Amendments to Glengarry Eaglehawk Flood Study (2021)

Project name Amendment to Glengarry Eaglehawk Flood Study 2021

1. Introduction

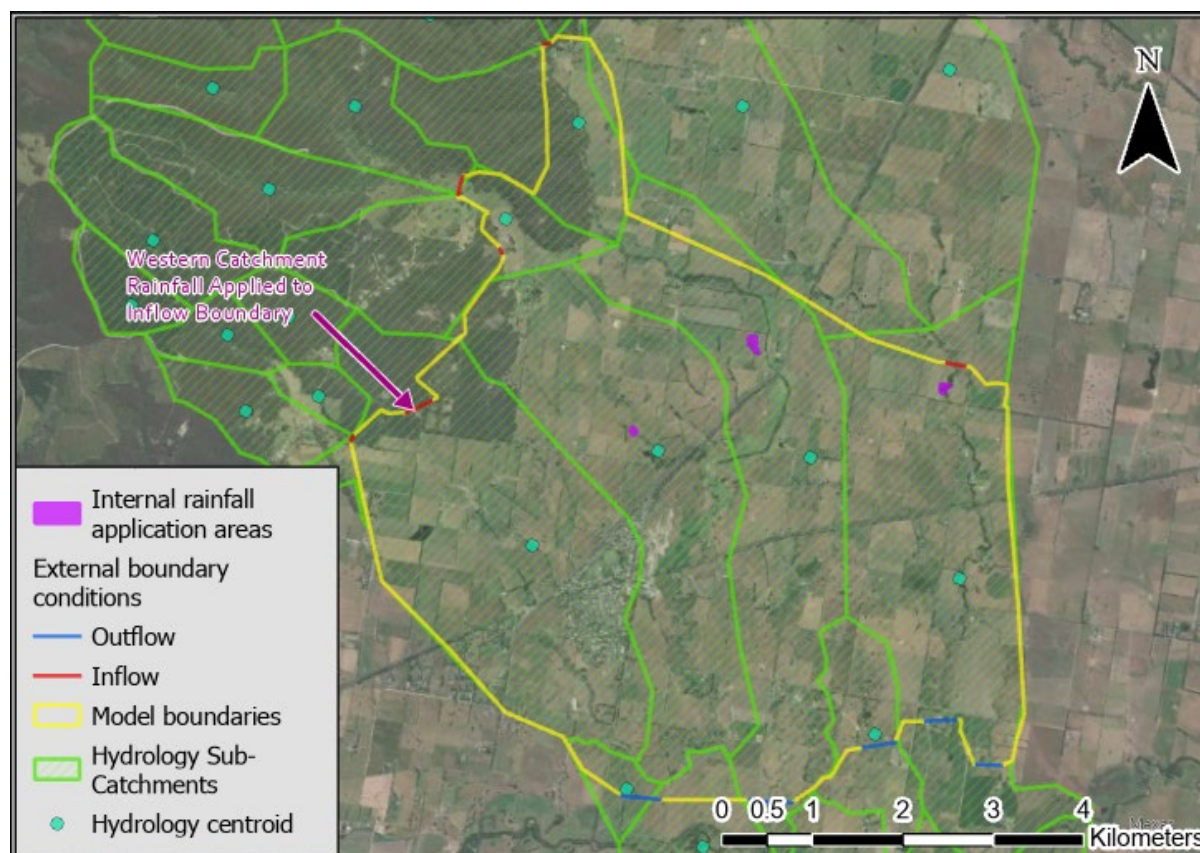
The amount of Source of Area polygons used within the initial model were too few for the area they were representing. The rainfall generated within the hydraulic model area was being concentrated to only 4 small areas of the model. This in combination with the poor positioning of the Source of Area polygons (discussed below) resulted in flooding being overestimated in some areas and underestimated in others.

The rainfall needed to be better distributed, either by:

- Dividing the sub-catchment further, each with their own application area.
- Or, using rain on grid to apply the rainfall evenly across the entire model boundary (which is the method this amendment used).

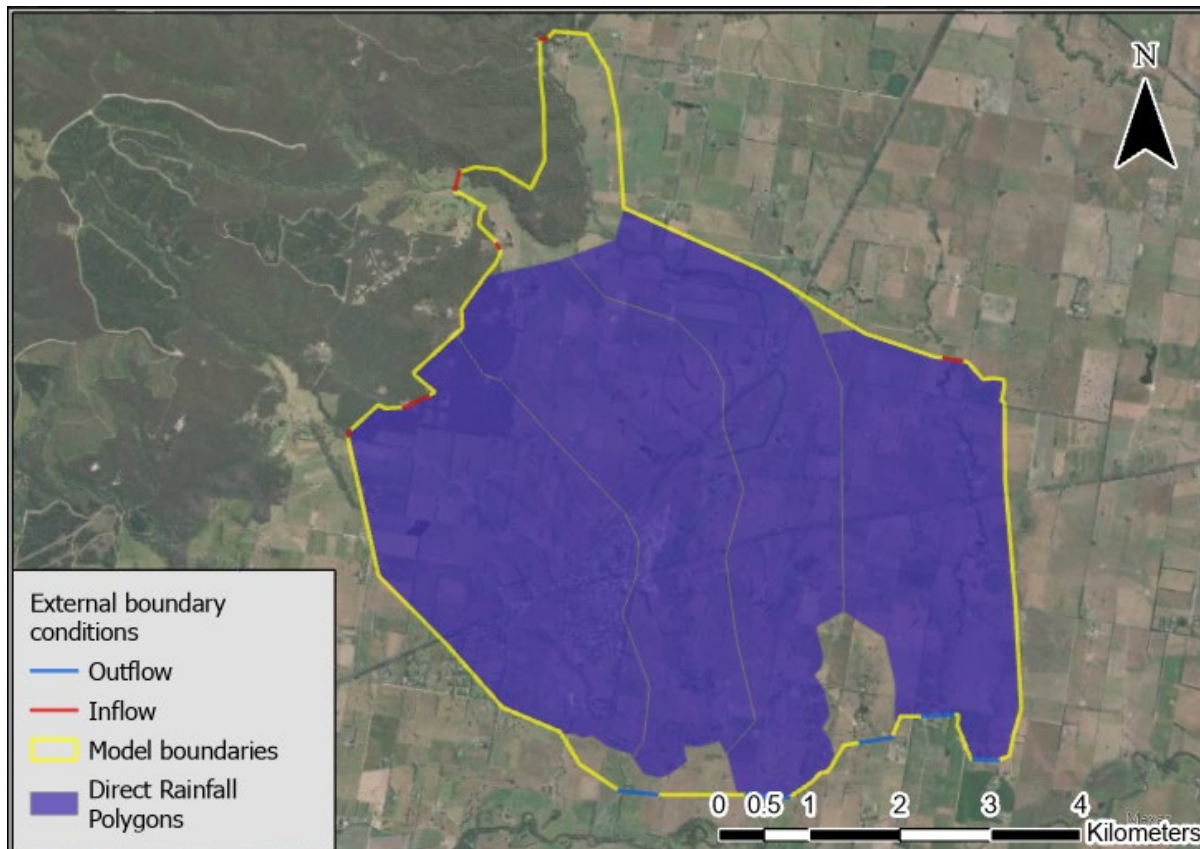
The internal rainfall application areas were replaced by Direct Rainfall polygons. This feature applies rainfall depths directly to each 2 metre by 2 metre cell in the hydraulic model grid. This is closer to how rainfall works in real life.

The external inflows shown in red below were kept as there were issues with these.

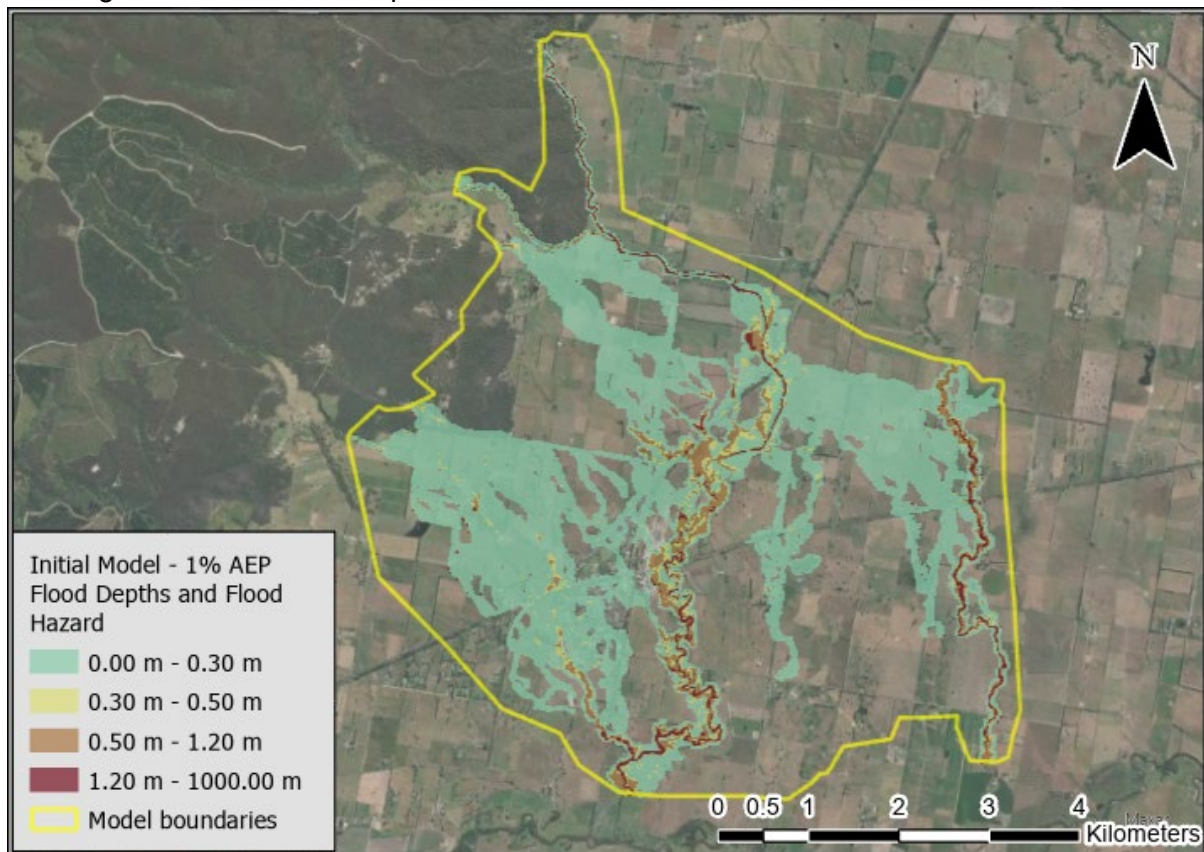
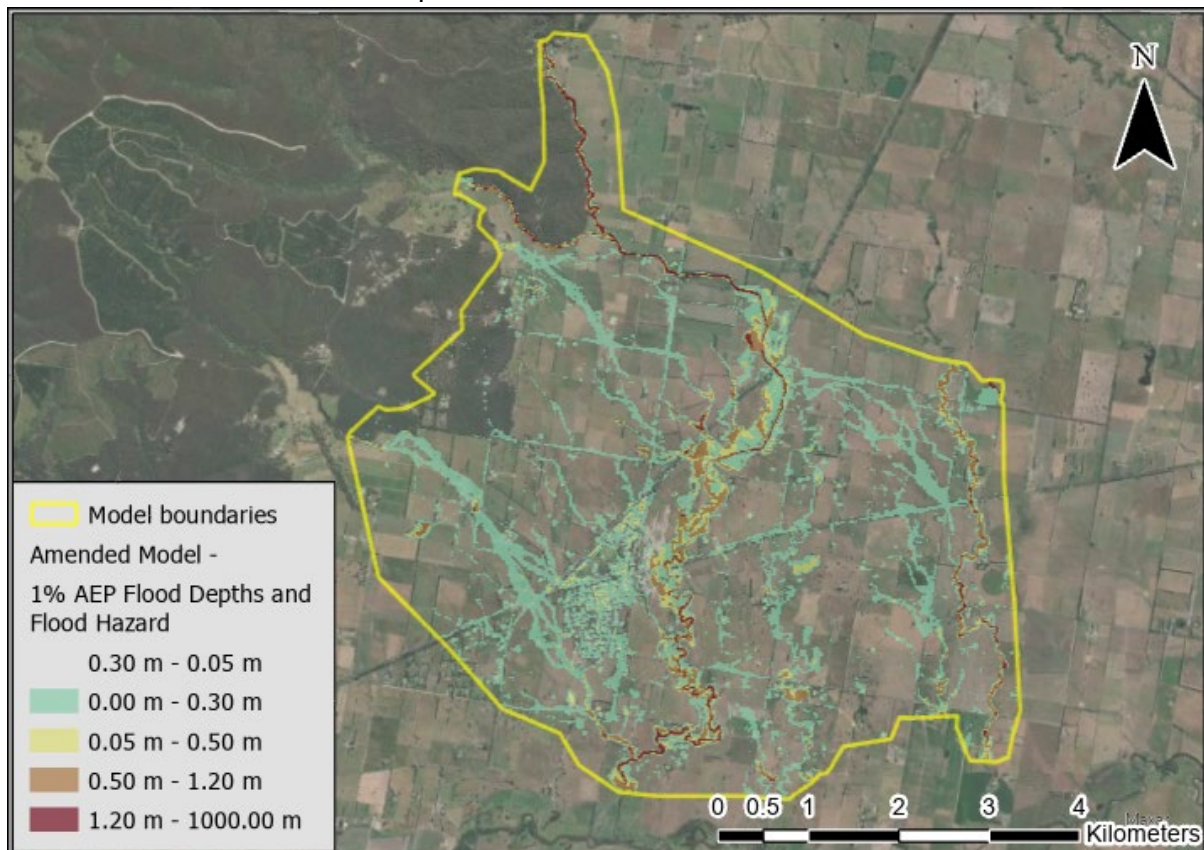
The original 1% AEP flood depth results are shown below:

The amended 1% AEP flood depth results are shown below:

The amended results are generally less extensive and more flow paths active.
